# SERVICE BULLETIN REVISION NOTICE

OIL — INTRODUCTION OF OPTIMIZED DESIGN FEATURES TO THE OIL TANK, THE PRESSURE PUMP AND FILTER HOUSING, THE SCAVENGE OIL PUMP, THE SCAVENGE OIL FILTER ASSEMBLY AND THE TRANSPORTATION FITTINGS.

Turbojet Engine Service Bulletin No. V2500 79-0101 Revision No. 1 dated November 17, 2016.

# SERVICE BULLETIN

DETAILS OF NEW FIGURE-ITEMS OF THE SPACERS INTRODUCED BY THIS  
SERVICE BULLETIN TO THE OIL SCAVENGE PUMP  
FIGURE 1

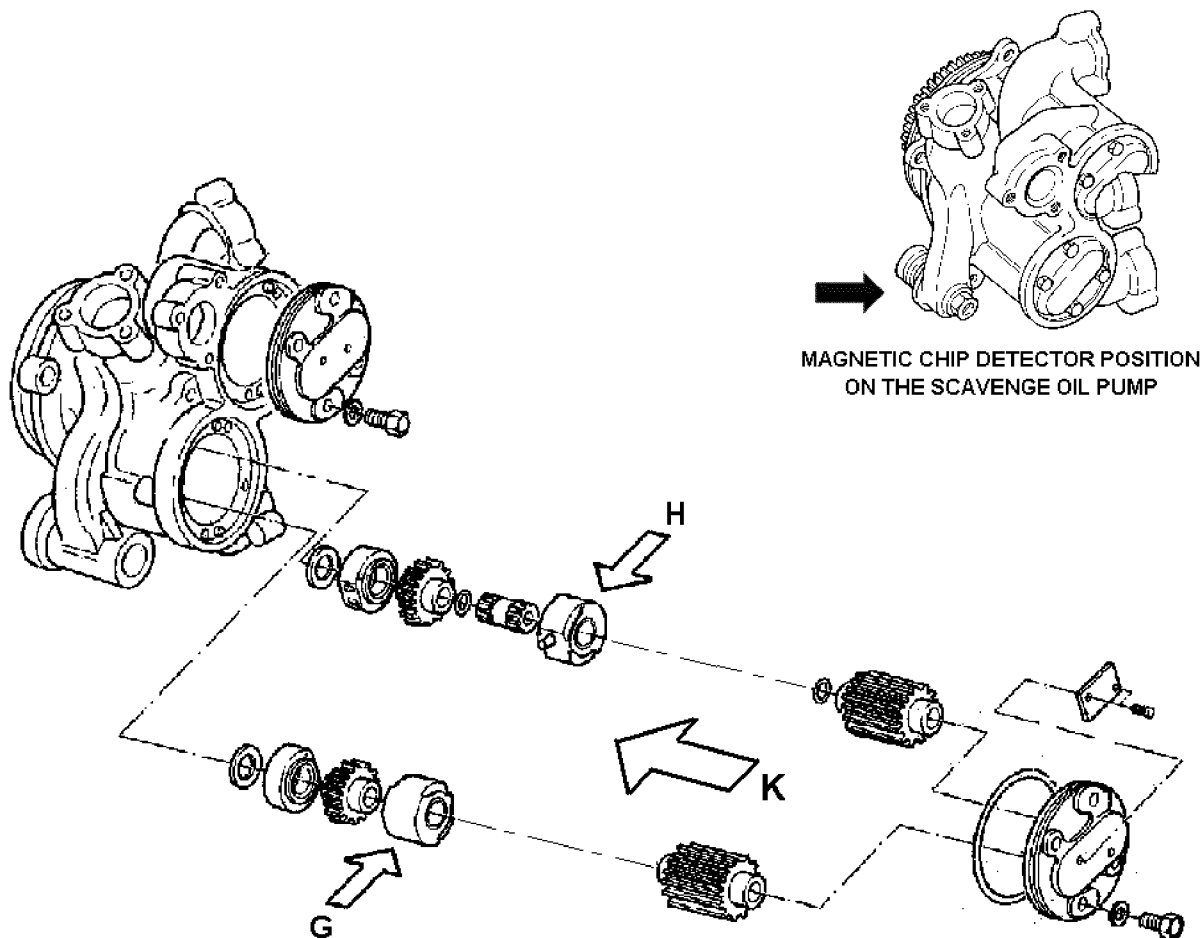
- D. To do the change of configuration required to introduce this Service Bulletin, the parts that must be replaced are those identified in Figure 1.

DETAIL G - OLD CONFIGURATION	
01-197	4B7368
01-198	4B7368CL01
01-199	4B7368CL02
DETAIL G - NEW CONFIGURATION	
01-507	4B7384
01-508	4B7384CL01
01-509	4B7384CL02

DETAIL H - OLD CONFIGURATION	
01-225	4B7369
01-226	4B7369CL01
01-227	4B7369CL02
DETAIL H - NEW CONFIGURATION	
01-500	4B7385
01-501	4B7385CL01
01-502	4B7385CL02

- E. Discard the parts to be replaced with the new parts. Refer to Material Information section.
  - F. To assemble the pump, refer to Reference 2 or 3, CMM, TASK 79-22-41-460-401 and the relevant criteria for the selection of components. The current criteria are applicable to the spacers introduced by this Service Bulletin. Refer to Figure 2 to ensure the correctness of the reciprocal position of the new spacers, and the installation of the set of new spacers into the pump.
